Cascades Diversion Dam Removal Project

Finding of No Significant Impact,
Merced Wild and Scenic Rivers
Section 7 Determination, and
Wetland Statement of Findings
May 2003

Yosemite National Park

National Park Service
U.S. Department of the Interior

Figure II-3
Alternative 2 - Complete Dam Removal

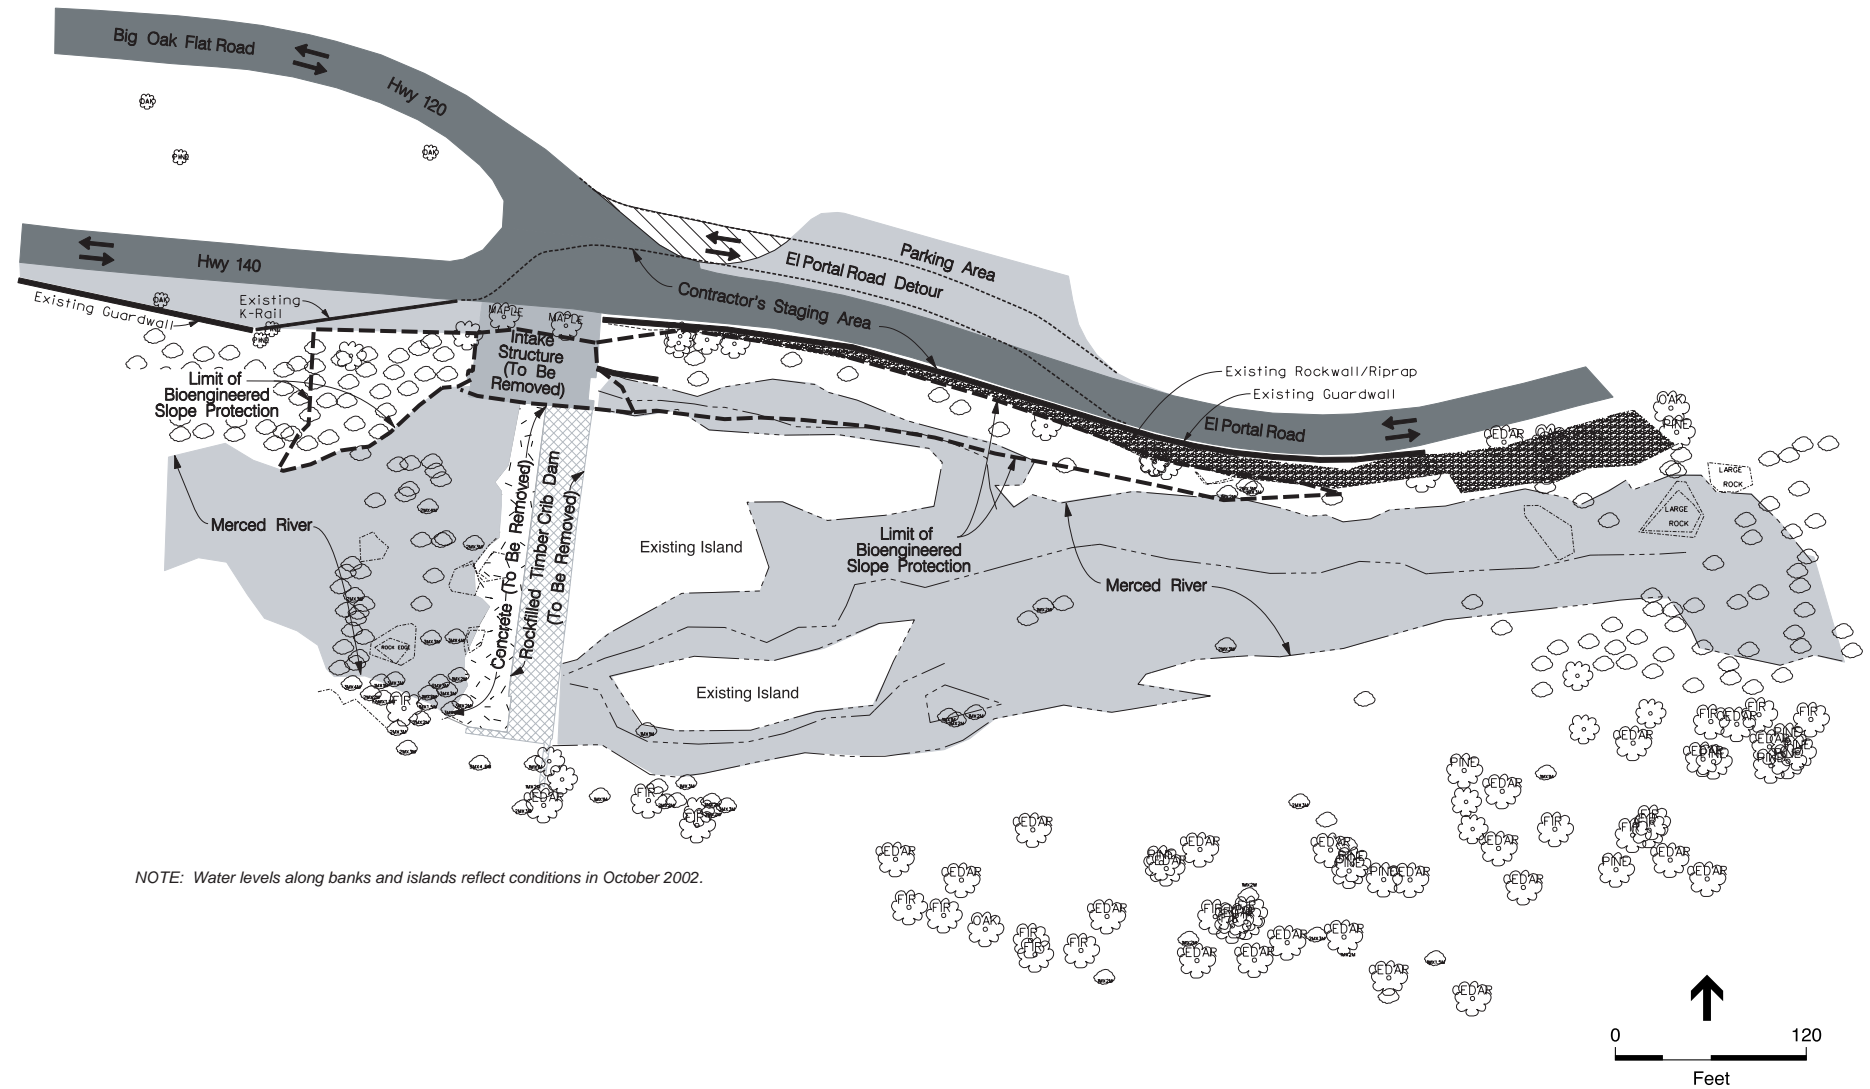
Page II-7, Figure II-3 has been revised to show the northern edge of the bioengineered slope protection system in the vicinity of the intake structure (see following page). (Individual, Email. #10-3)
